ADDENDUM #1 TO THE TECHNICAL DRAINAGE STUDY

FOR
Red Rock Elementary School

DS-05647

**ADDENDUM #1 to the Technical Drainage Study for Red Rock Elementary School
CLV #5647**

FIGURE 8

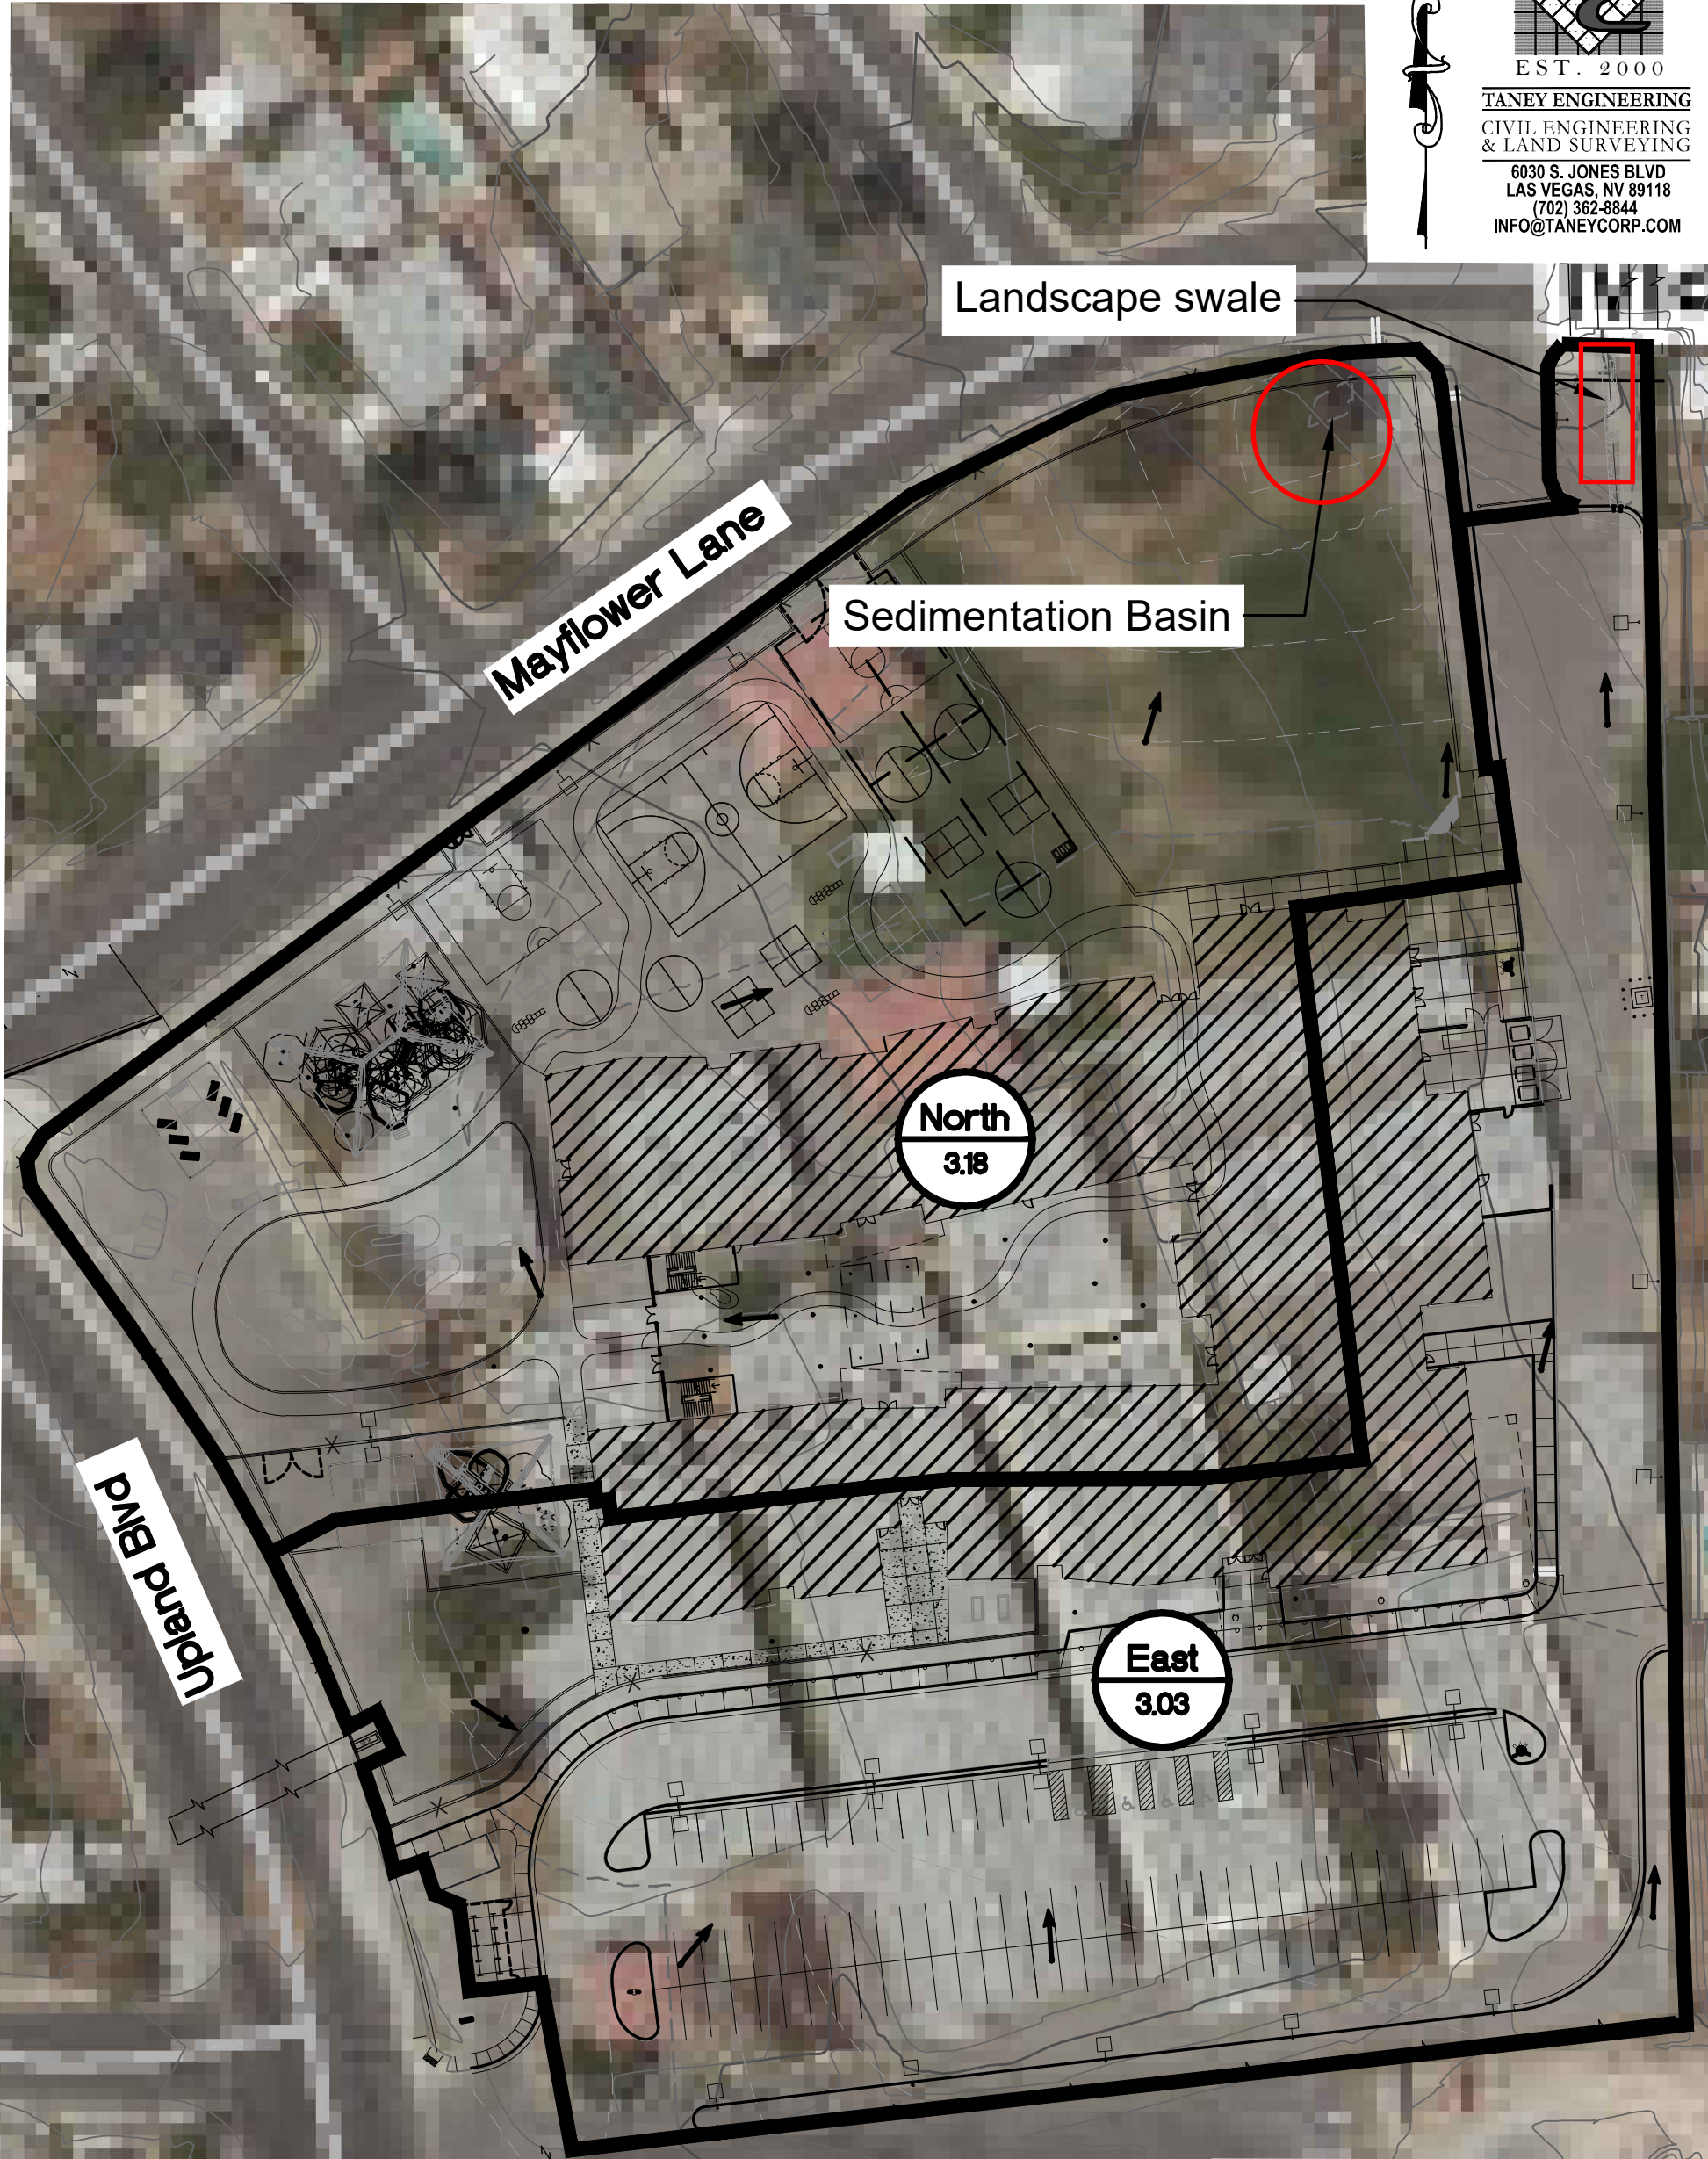
Comment 8: The following comments apply to Figure 8, Offsite Basins:

a. Provide flow arrows on the exhibit.

b. Provide contours and contour labels on the exhibit so we may verify the basin lines.

c. Fix the basin boundaries of all offsite basins. From the aerial provided the basins look misaligned. For example, the western boundary of all basins bisects several homes and Basin XOF1A cuts off the northwestern portion of Wisteria Lane and does not consider the high point south of the intersection of Mallard Street and Wisteria Avenue. The street view of Upland Boulevard

shows a valley gutter across Temple Drive at the intersection, and basin XOFIB is not accounting for the additional area.

- d. Extend the boundary of Basin XOF2B east along Mayflower Lane to align better with the eastern boundary of the project site.**

- e. Show the computations for Sections Q and R on the table of cross sections.**

Flow arrows have been added, and the revised exhibit is included with the submittal.

Contours and contour labels have been added.

The offsite basins boundaries were demarcated based on the regional subbasins from Master plan Update (MPU). The basins have been aligned with the aerial and lot lines and the revised exhibit is included with the submittal.

The boundary of Basin XOF2B has been extended along Mayflower Lane to align to the eastern boundary of the project site and is shown in the Existing condition figure attached to the submittal.

The computations for Sections Q and R have been added and shown on the table of cross sections.
